# SCHWEIZER SERVICE INFORMATION NOTICE

N-219  
24 Aug 1990

SUBJECT: DETAILED INSPECTIONS OF UPPER PULLEY STACK-UP

Figure N-219-1. Determining Proper Orientation of Driven Spline Spacer

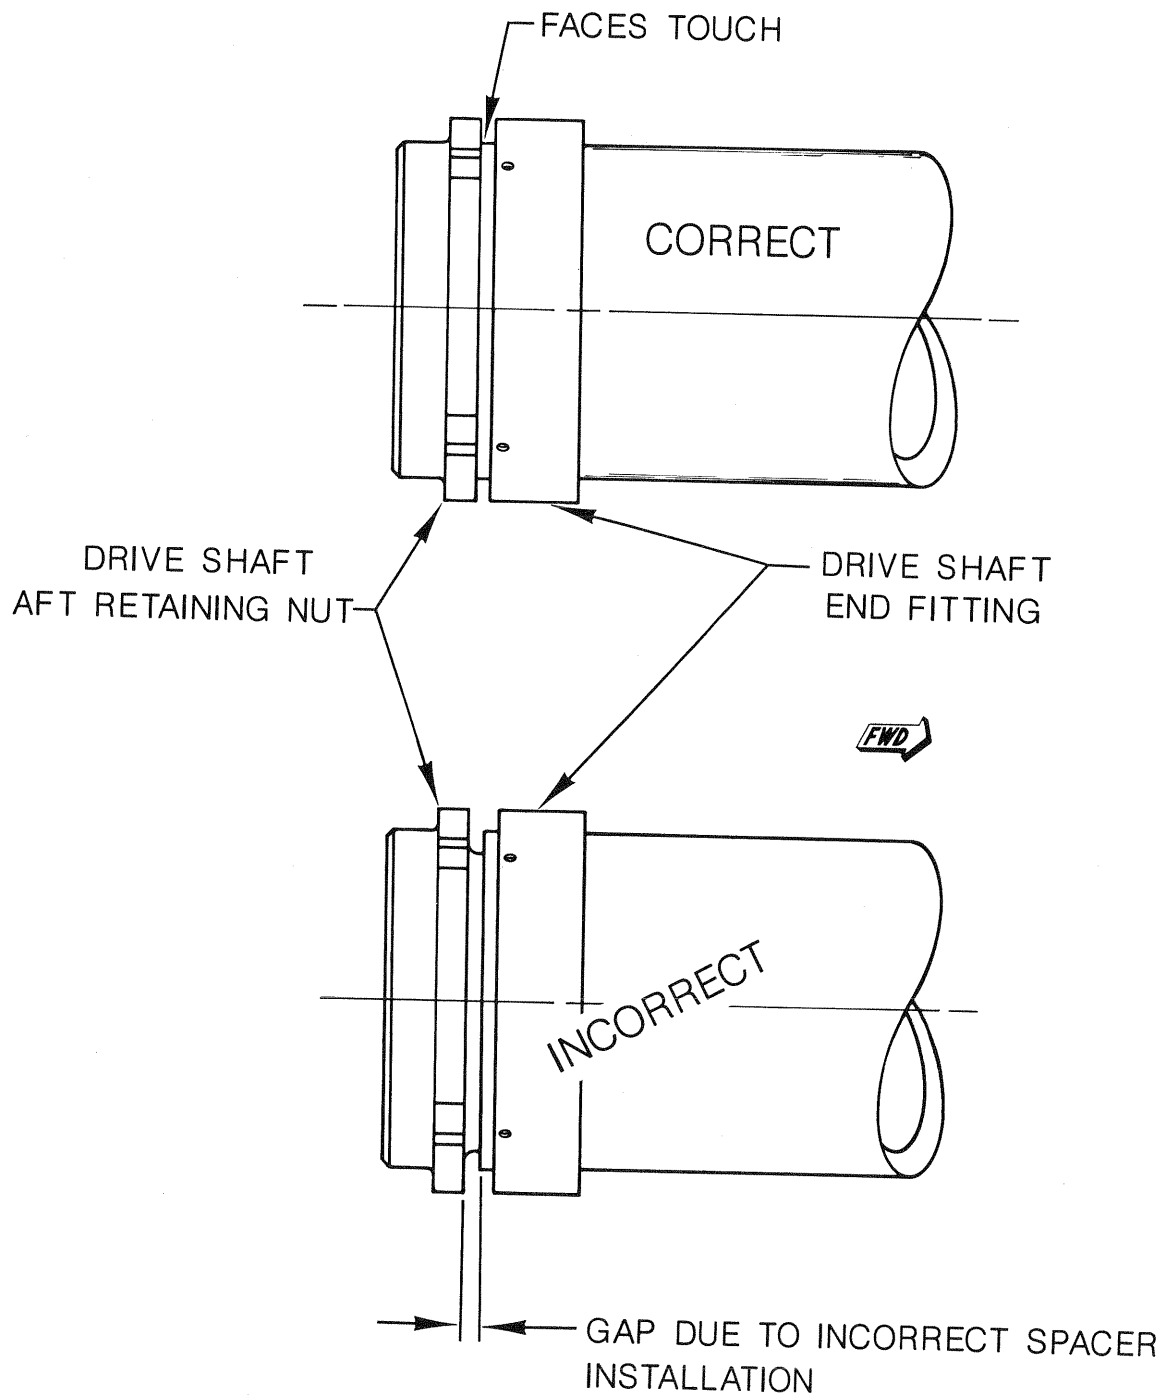
- d. Verify that driven spline spacer is installed in proper orientation (Figure N-219-1). Proper orientation of this spacer may be verified by inspecting the drive shaft aft retaining nut and drive shaft end fitting. (If tail rotor drive shaft and transmission are installed, look through the inspection hole.) If installed properly, proceed to step f. below.
- e. If driven spline spacer is NOT installed in proper orientation, remove tail rotor transmission from helicopter (BHMI, Section 10), remove and reinstall driven spline spacer in proper orientation (HMIC).
- f. If removed, reinstall assembled tail rotor drive shaft and transmission (BHMI, Section 10). Connect tail rotor control rod to tail rotor swash plate bellcrank assembly (BHMI, Section 9).
- g. Record compliance with Part I in the aircraft records.

Figure N-219-2. Identification and Compatibility of Pinion Oil Seal Collar

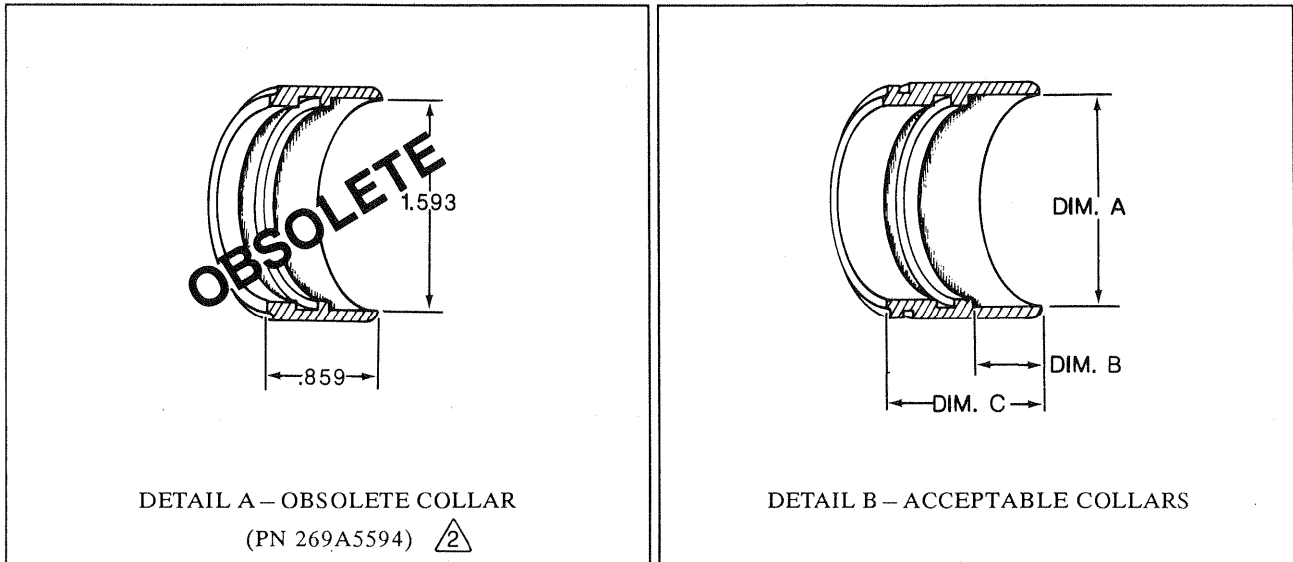
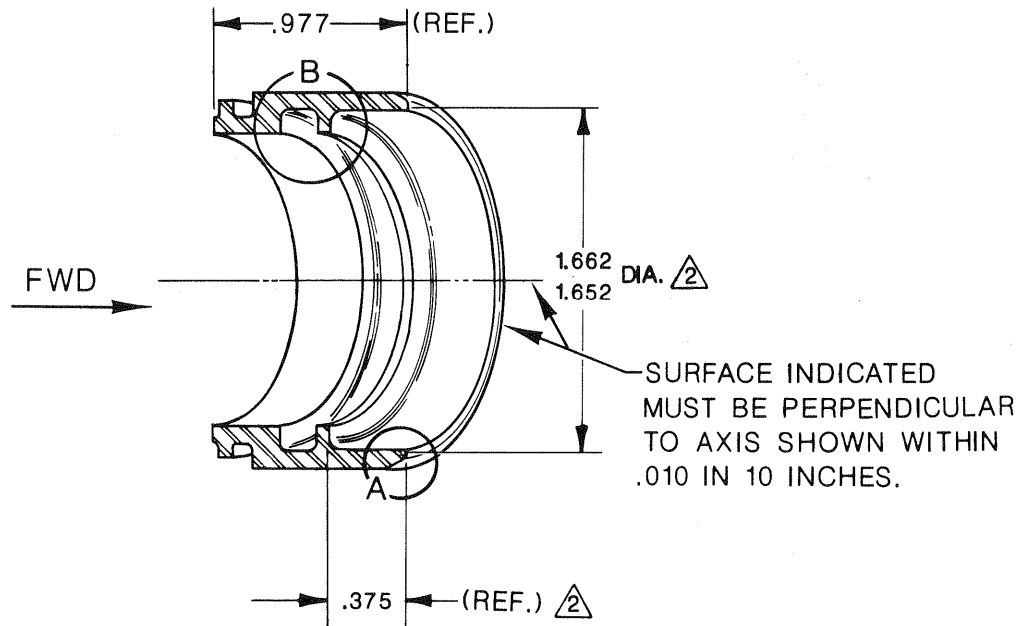
- a. Remove belt drive transmission and forward upper H-frame bearing from helicopter (BHMI, Paragraph 10-37).
- b. Use the dimensions listed on Figure N-219-2 to identify collar.
- c. If collar is identified as a 269A5594 collar, remove and discard collar. Order a new 269A5178-9 collar for replacement or consult Figure N-219-3 for an approved alternate collar. Conspicuously mark or tag 269A5594 collar to prevent inadvertent return to service.

As specified by the chart in Figure N-219-2, helicopters equipped with 269A5103-21, -31, or -41 pinion assembly, must incorporate either a 269A5178-9 or -11 collar. The -11 collar may be created from an existing 269A5178-3 collar (Figure N-219-3). The -9 collar may be obtained through a SAC Service Center or Distributor. Both collars incorporate a deeper bore in the forward end. This deeper bore and a new shimming procedure are used to preclude interference between the inside surface of the collar and the serrated threads on the pinion.

- e. Remove seven nuts securing pinion oil seal retainer to main transmission and remove retainer. Set position of proper collar (Figure N-219-2 and HMICI, Section 6, as amended by R-21, Paragraph 6-5, step i.).
- f. Install oil seal retainer, gasket, collar and O-ring (HMICI, Section 6, Paragraph 6-13).
- g. Reinstall belt drive transmission as follows:
  - (1) Perform steps a. and b. of BHMI, Paragraph 10-43.
  - (2) If helicopter is equipped with 269A5103-41 or subsequent dash (-) number pinion assembly, proceed to step g.(4).

Figure N-219-3. Modification of 269A5178 Pinion Seal Collar to 269A5178-11 Configuration

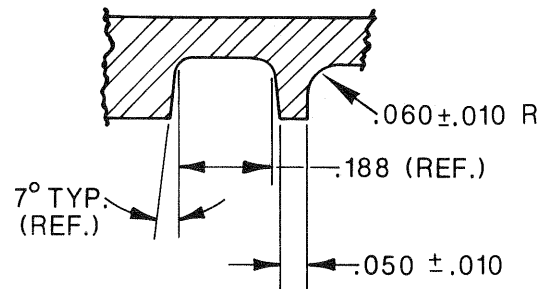
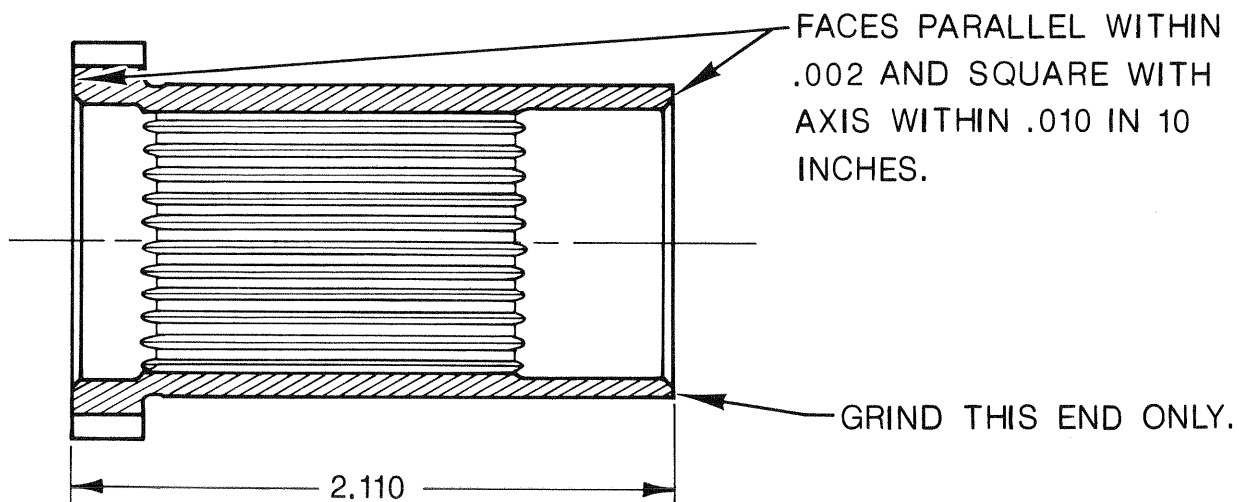
- d. On helicopters which incorporate 269A5103-21, -31, -41 or subsequent dash (-) number pinion assembly, order 269A5178-9 collar for replacement. (Refer to Figure N-219-3 for an approved modification to 269A5178-3 collar as an alternative to ordering new collar.)

1. ALL DIMENSIONS IN INCHES.
- $\triangle 2$  MODIFY EXISTING -3 COLLAR BY MACHINING FORWARD END I.D. TO DIMENSIONS SHOWN. I.D. OF COLLAR TO BE 1.657±0.005 IN. DEPTH OF BORE TO BE AS REQUIRED TO ACHIEVE .050 DIM. SHOWN IN DETAIL B.
- $\triangle 3$  MACHINE .030/.040 RADIUS 360° AROUND FORWARD END I.D. OF COLLAR AS SPECIFIED BY DETAIL A. RADIUS MUST BE BLENDED SMOOTHLY INTO CHROME SURFACE ON O.D. OF PART. NO CRACKING, CHIPPING, OR FLAKING PERMITTED.
